Appendix L Utilities

From: Schaun Valdovinos
Sent: Thursday, April 06, 2017 5:44 PM
To: Dave Rodgers; Quayle, LaWana
Cc: A088367_Mail; Nina de Witt; Aaron McDonald; Kali Dickerson
Subject: Totem Lake - PSE Power Line Sections
Attachments: PSE_Section_A.pdf; PSE_Section_B.pdf; PSE_Section_C.pdf; PSE_Section_D.pdf; PSE_Plan.pdf; PSE_Sections.dwg

From: Schaun Valdovinos
Sent: Friday, April 14, 2017 3:59 PM
To: Lin, Jimmy; Dave Rodgers
Cc: Aaron McDonald; Jennifer Lathrop; Risch, Bob; Bresnahan, John; A088367_Mail; Kali Dickerson
Subject: Totem Lake SCL Facilities - Suspended Ring Option
Attachments: SCL_Plan.pdf; SCL_Section_1.pdf; A088367 SCL Clearance.dwg; 170411 TL - Suspended Ring 01 - Board Views_006.jpg

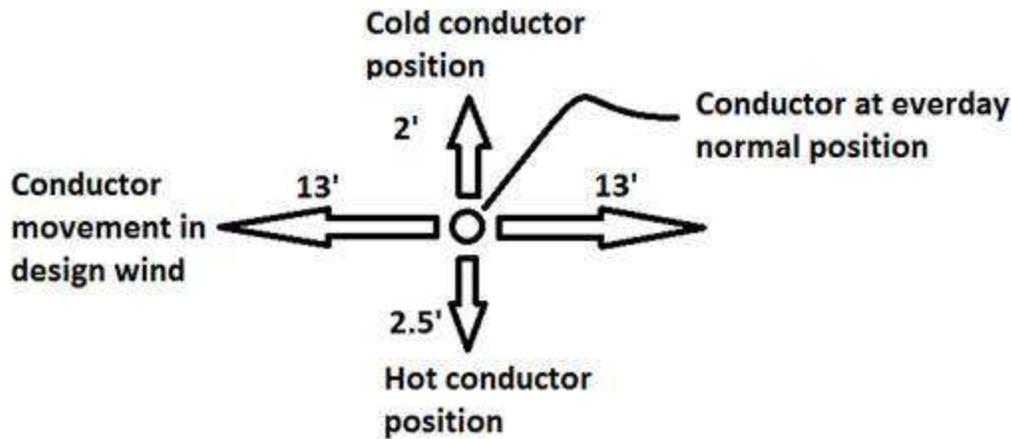
Please see below for the conductor movement envelope that the 230 kV circuit is designed for.

This diagram only applies for the area above the CKC because as you move further north, the movement envelope gets bigger. The clearance required from the conductor **in any position** to the bridge/bridge elements is 11.5' horizontal and 16.5' vertical. For lighting support, the clearance required is 8.0' horizontal and 8.5' vertical to the conductor in any position. We currently have no plans for upgrades or replacements. The access requirements would be the similar for the Chief Sealth Trail project.

SECTION 1
 STA 19+81.61

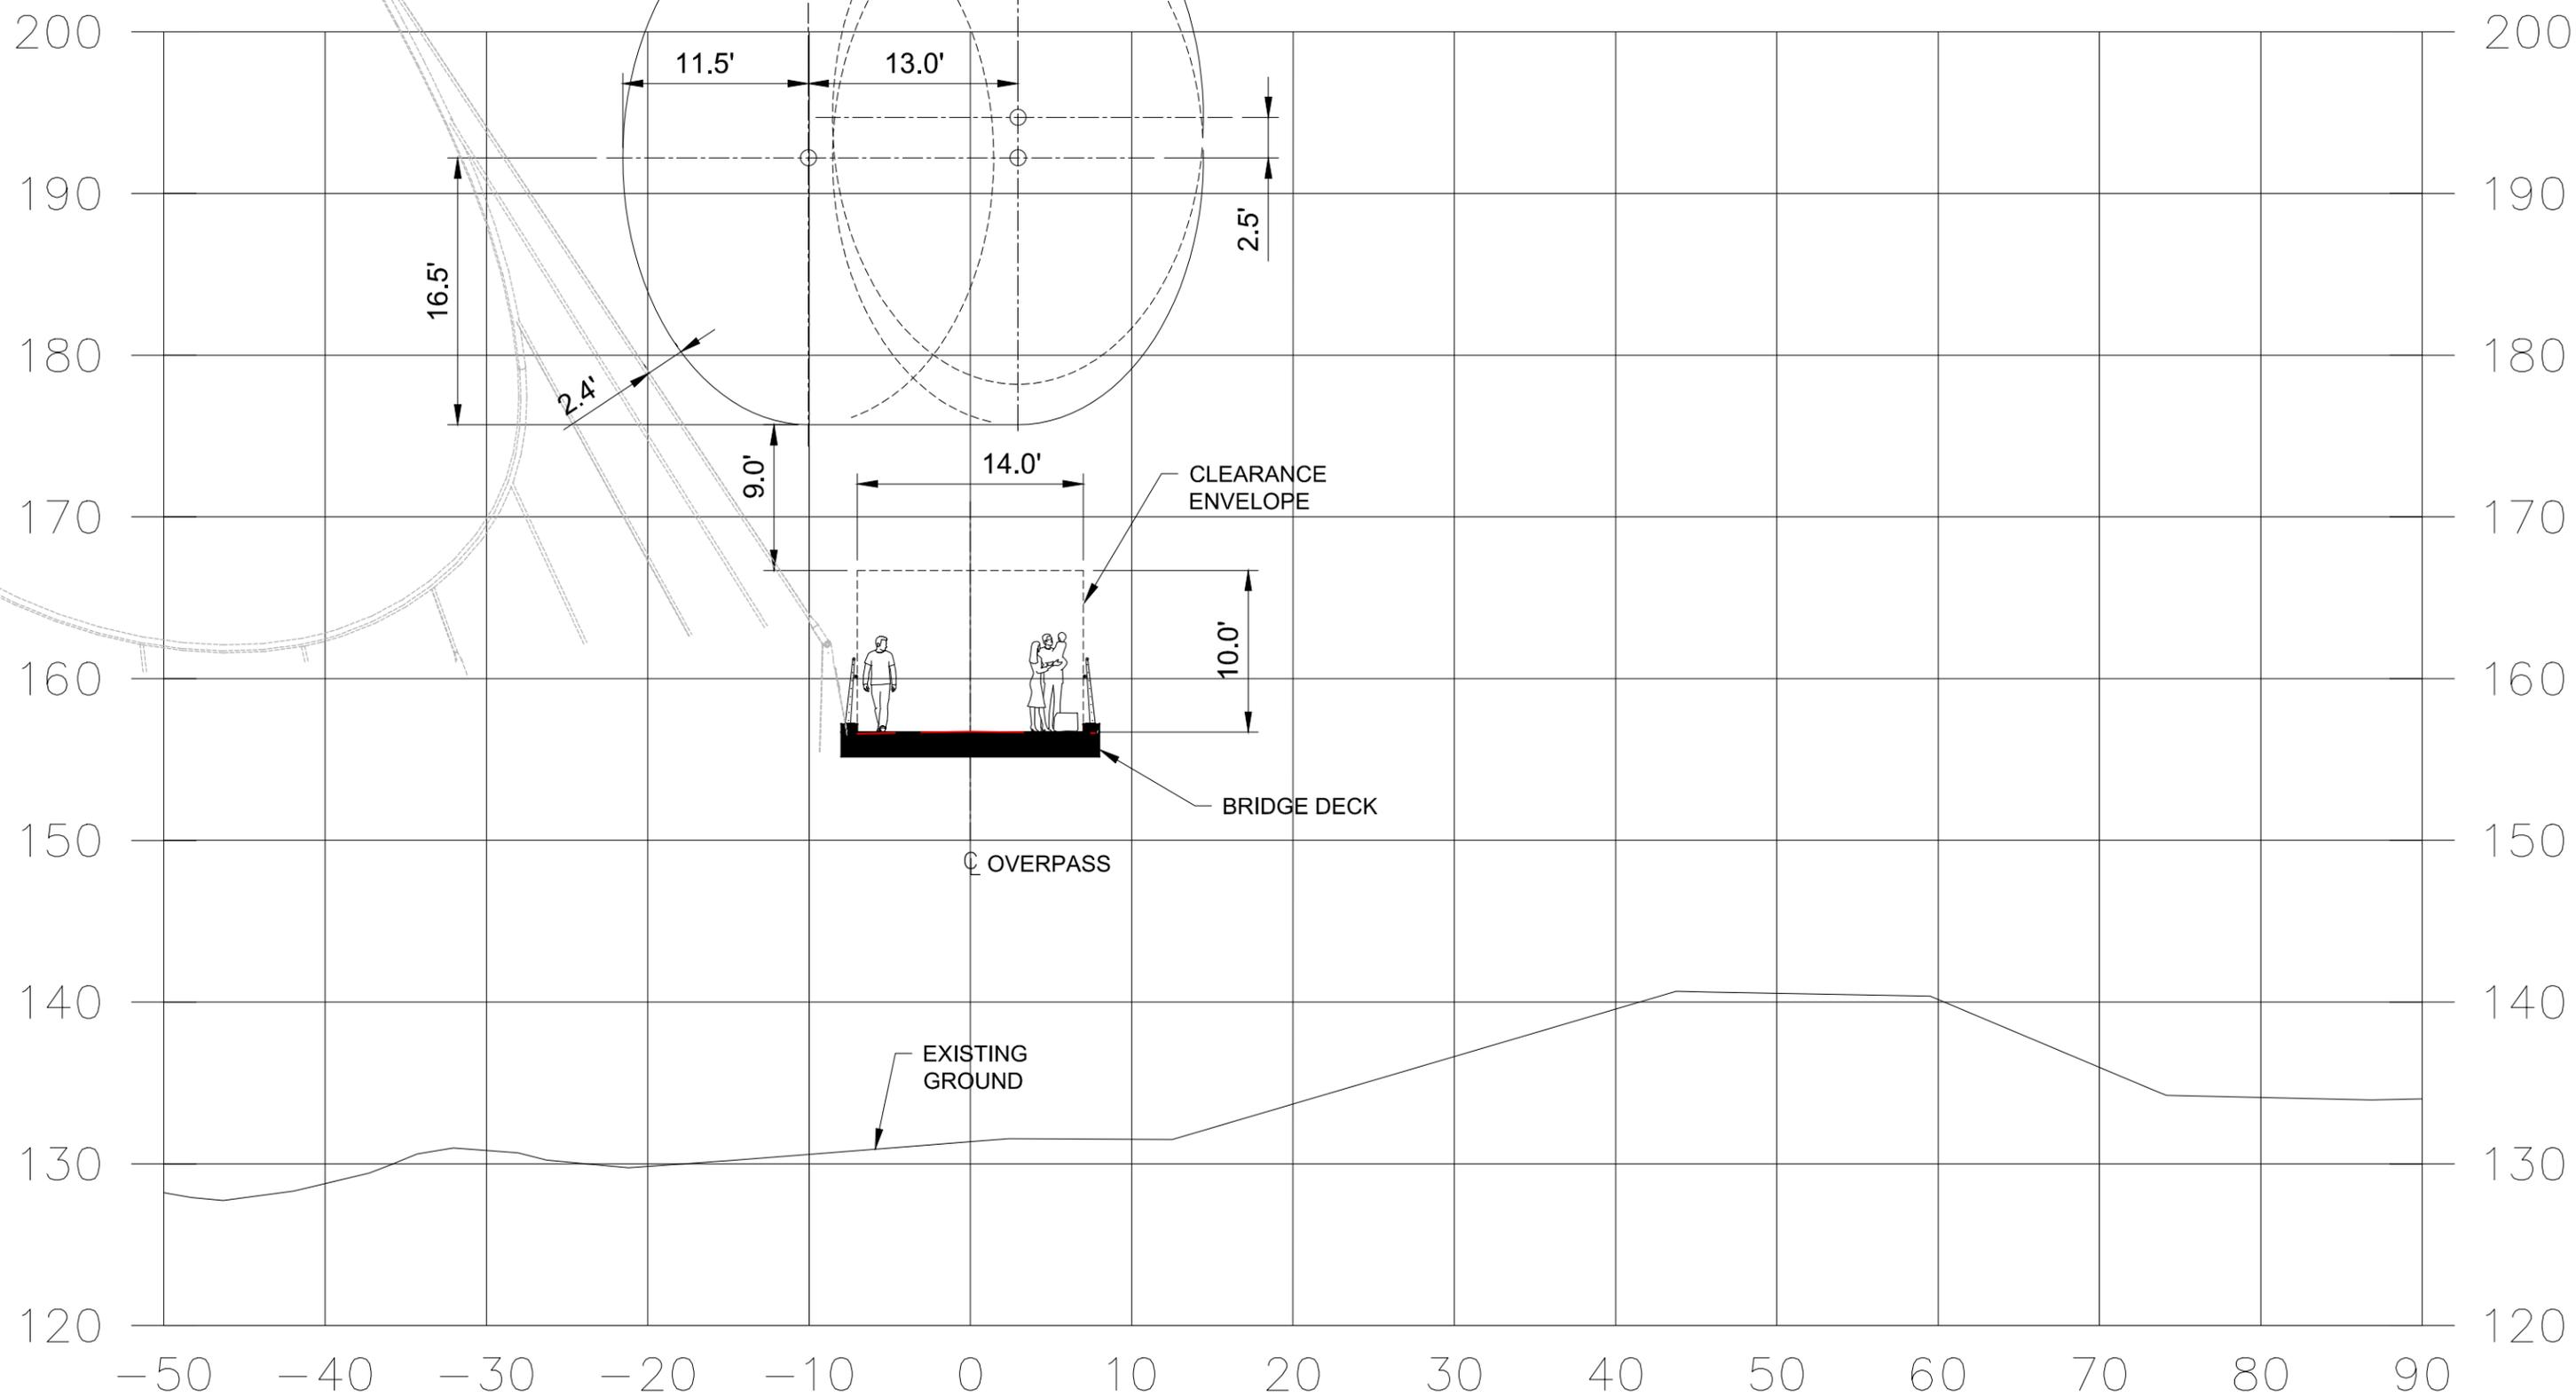
One thing that's not shown is the height of lighting or features. The scrapbook diagram below shows some kind of structure that extends over the walkway. Those should be included in determining clearance to the transmission line. Other than that, the clearance in the diagram Section 1 show there is adequate clearance to the transmission line.
